TECHNICAL MEMO

FROM: Ethan Richardson, Shore Gold Inc.

SUBJECT: Response December 3, 2013 Federal Questions, Annex 'A'

Star-Orion South Diamond Project – Federal Environmental Assessment
Additional Information Request – Traditional Land Use by the James Smith Cree Nation

Date: December, 2013	Analyst: BD	Figure A1-ci
Projection: UTM Zone 13	QA/QC: ER	Datum: NAD27

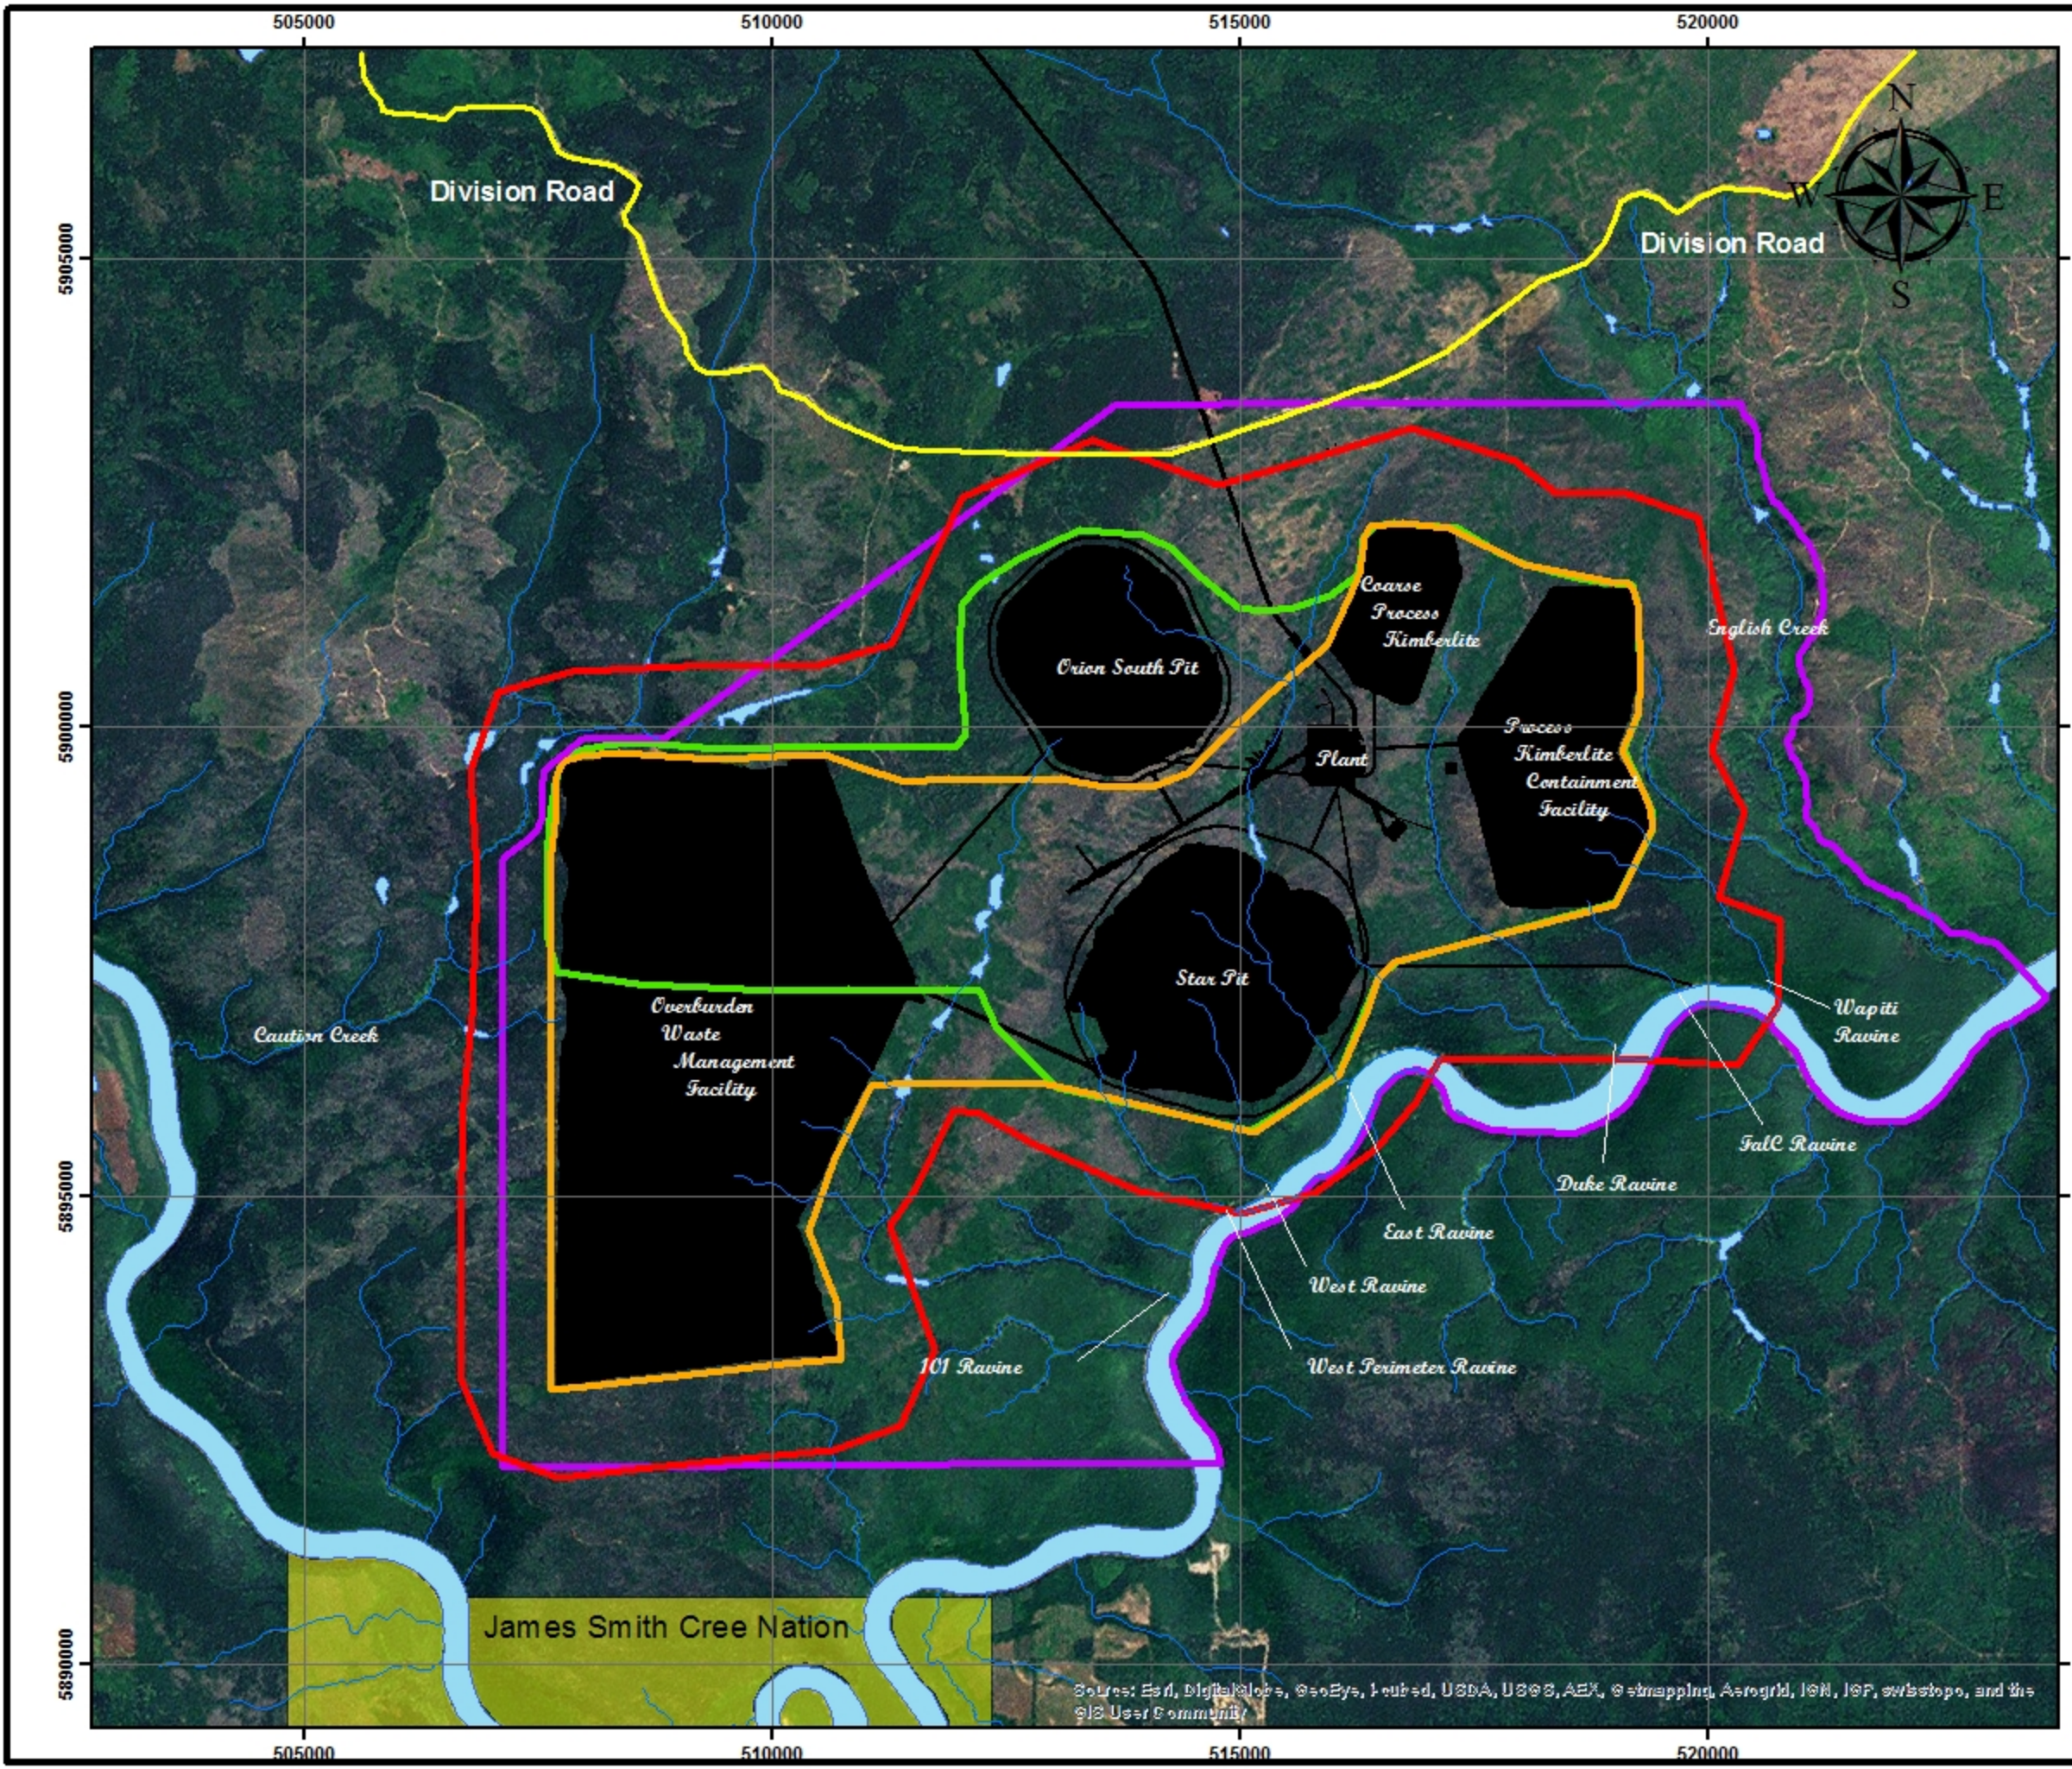
- Areas where there could be dust deposition on soil and vegetation from the Project. Section 6.2.2 of the EIS states that dust deposition could occur 400 m from the mine site.

- c. As stated in the REIS, dust deposition may occur within 400 m of active mine facilities (Figure A1-ci). This area represents 7,425 ha, however progressive reclamation, and the progressive closure of facilities will mitigate the spatial extent and duration of any dust deposition. This also includes areas within the fence line. Note also that the application of a 400 m zone for dust is not appropriate for all disturbance types as discussed in Section 6.3.2.5, p. 6-54 of the REIS. Potential impacts from dust on vegetation communities are presented in Table 6.3.2-2 in the REIS and are considered throughout the REIS.

Date: December, 2013	Analyst: BD	Figure A1-cii
Projection: UTM Zone 13	QA/QC: ER	Datum: NAD27

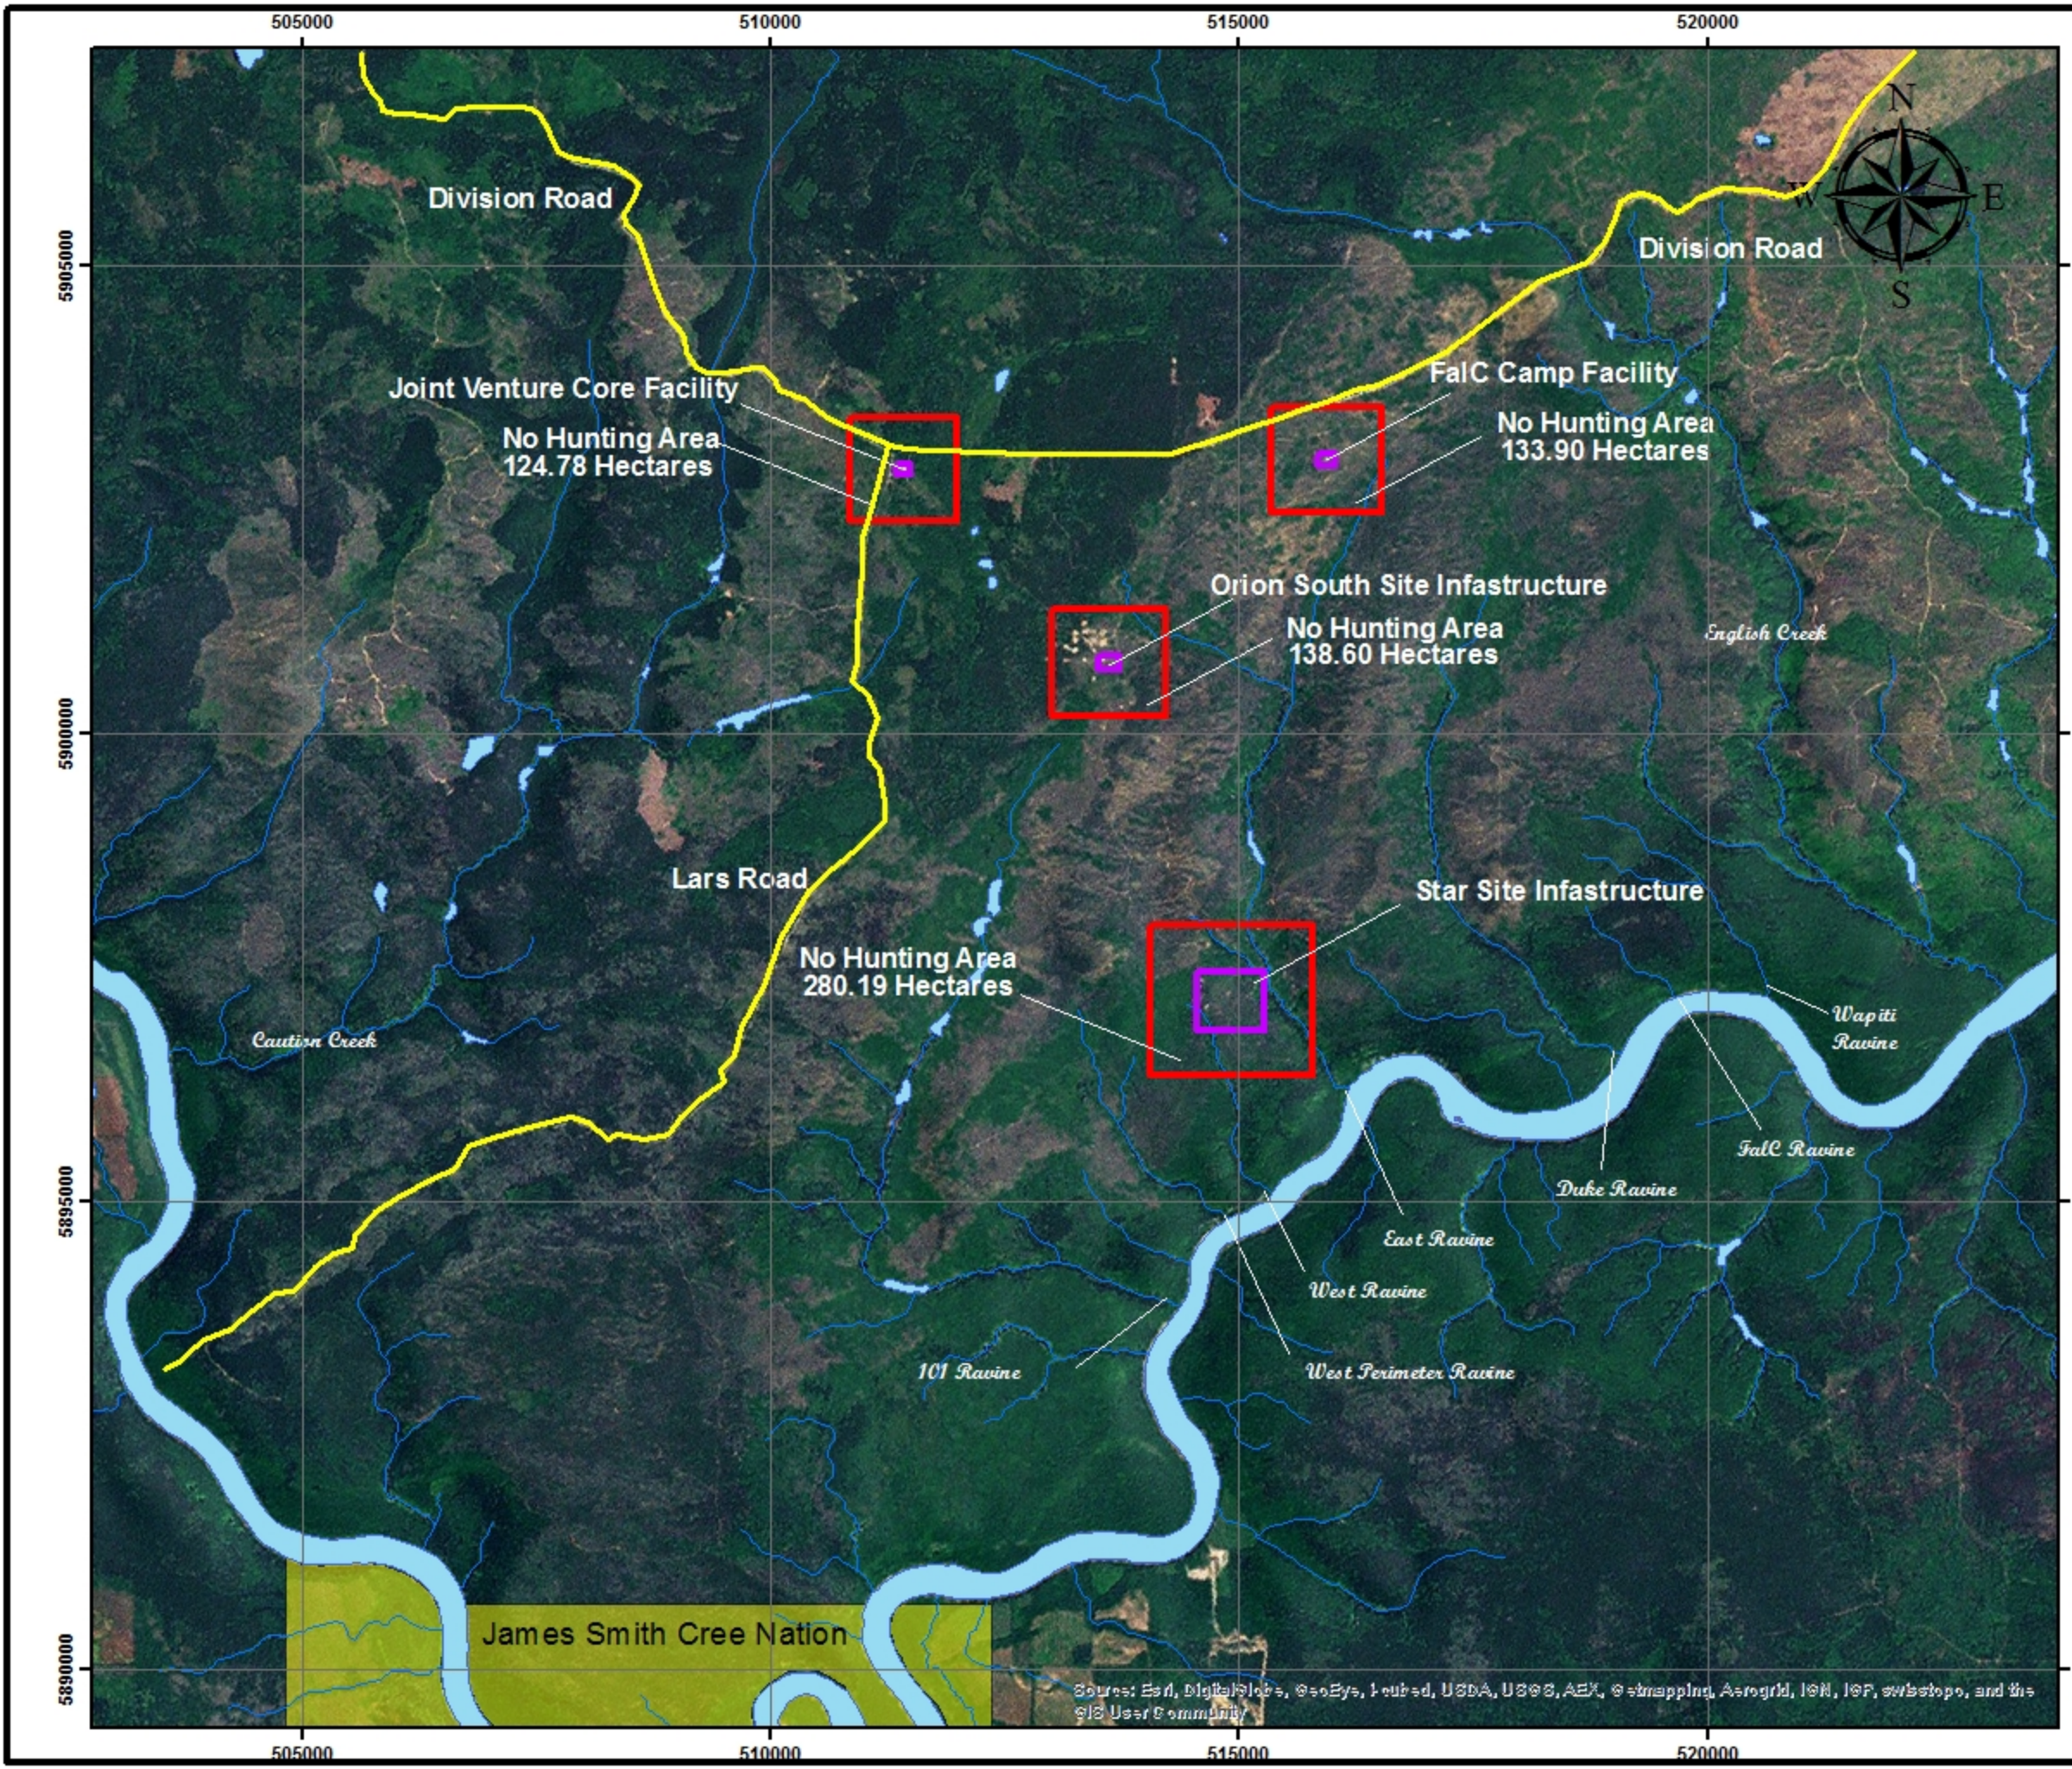
- Areas where there could be changes in viewscape within the Fort á la Corne (FaC) forest that are rated high in sensitivity.
 - Areas where there could be a loss of functional wildlife habitat caused by project noise disturbance and human presence. For example, Table 6.3.3-3 of the EIS (page 6-76) states that within 1000 meters of the project footprint, ungulate populations would decrease by 9.1 to 12.4% assuming 100% functional habitat loss.

Functional habitat loss is discussed in Section 6.3.3.4 of the REIS. A total area of 10,120 ha, or an additional 4,739 ha lies outside of the fence line (Figure A1-cii) but within 1,000 m of Project facilities. Note that Section 6.3.3.4 of the REIS discusses this potential displacement, noting that displacement would be most during construction (a 4 year period) and reduce over time. Displacement and acclimatization to mining activity varies by species and time. These indirect effects on wildlife are considered in Section 6.3.3.4, the Traditional Land Use assessment, and throughout the REIS.

- a. Describe the spatial extent of current land uses within the FaIC forest that would exclude traditional hunting (a land tenure map would provide a good basis for this assessment). Provide a spatial representation of the remaining area that is available for traditional hunting.
- b. Re-calculate the area that would be available and accessible for traditional hunting taking into account the effects of the Project and current land uses on traditional hunting within the FaIC forest. Provide a spatial representation of the remaining area that is available for traditional hunting.
- c. Discuss the cumulative effects on traditional hunting taking into account the project effects, current land use and future foreseeable projects within the FaIC that would exclude traditional hunting. Provide a spatial representation of the remaining area that is available for traditional hunting.

- b. The area available and accessible for Traditional Hunting, when taking into account the Project effects and current land use remains as originally presented in the supplemental information referenced. All but the area around the current core shack presented in Figure A2-a lie within the original boundary encompassing up to 5,381 ha. Shore will commit to establishing a notification procedure with cooperation with potentially affected Aboriginal groups to facilitate traditional hunting within 500 m of project facilities. As such, there will be no additional effect.
